VARIANCE / FIELD CHANGE NOTICE

V/F: 20600-PSP-0005-2

PROJECT TITLE: Project Specific Plan for Area 6 Solid Waste Landfill Excavation Characterization

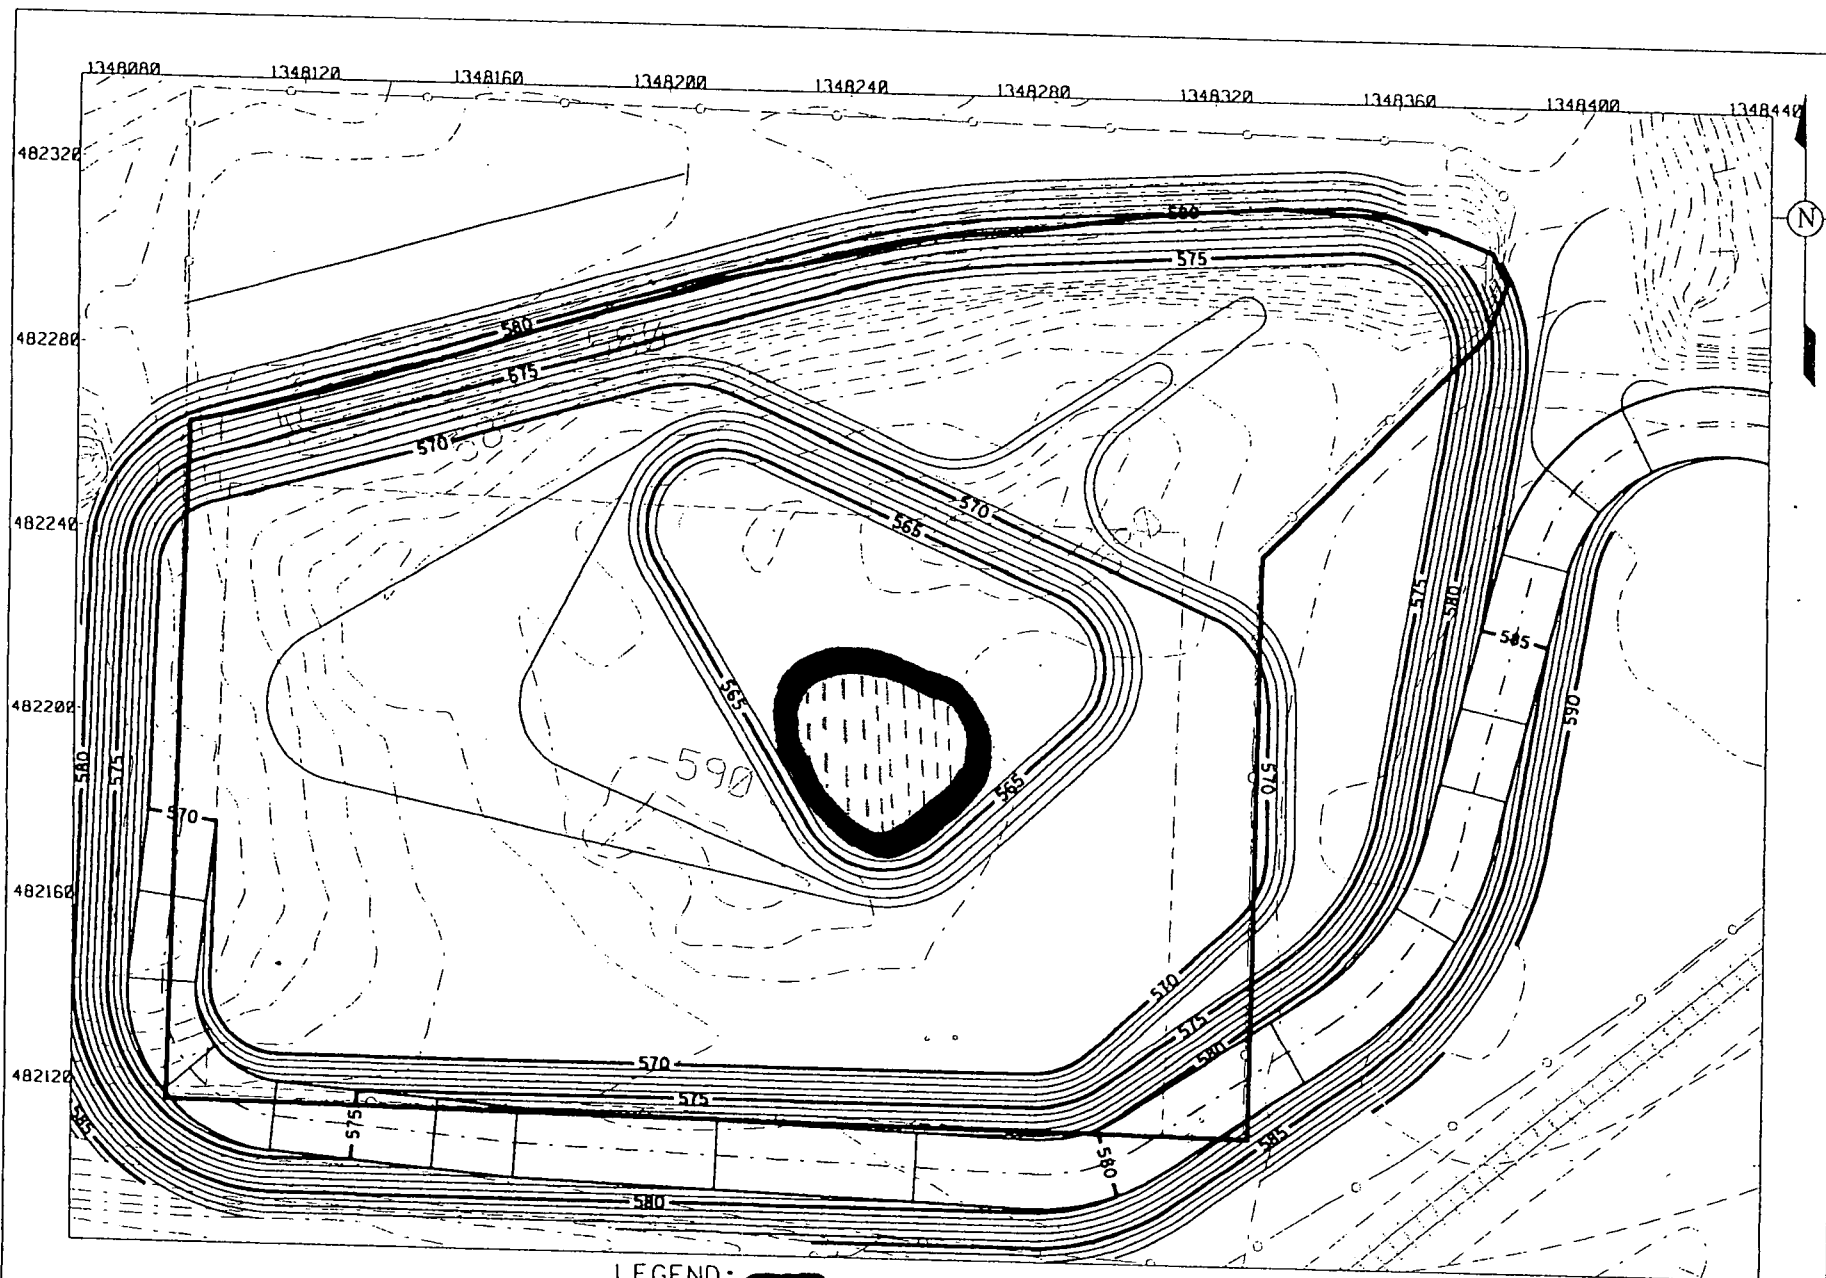
This Variance/Field Change Notice (V/FCN) documents the collection of surface grab samples in Solid Waste Landfill (SWL) to replace the real-time scan at the final grade, which is at 563' mean sea level (MSL). The area is approximately 40' x 40' and there are no sidewalls. See Figure 1 for the approximate area to be sampled. Coordinate with the Construction Lead for the exact location of the area.

The excavation floor will be divided into a 50' X 50' grid and a location will be marked at the center of each block. If the area is less than 50' X 50', then a minimum of 2 locations at representative spacing will be marked on the floor. At each location 1 sample will be collected for total uranium (TAL A), which will be analyzed at the onsite laboratory. These samples will be taken in accordance with the PSP. See Attachment 1 for the Sampling and Analytical Requirements.

Due to the wet field conditions in this area real-time scanning is not possible, therefore physical samples for total uranium will be taken and analyzed to replace the real-time scanning to ensure that no above-FRL material remains.
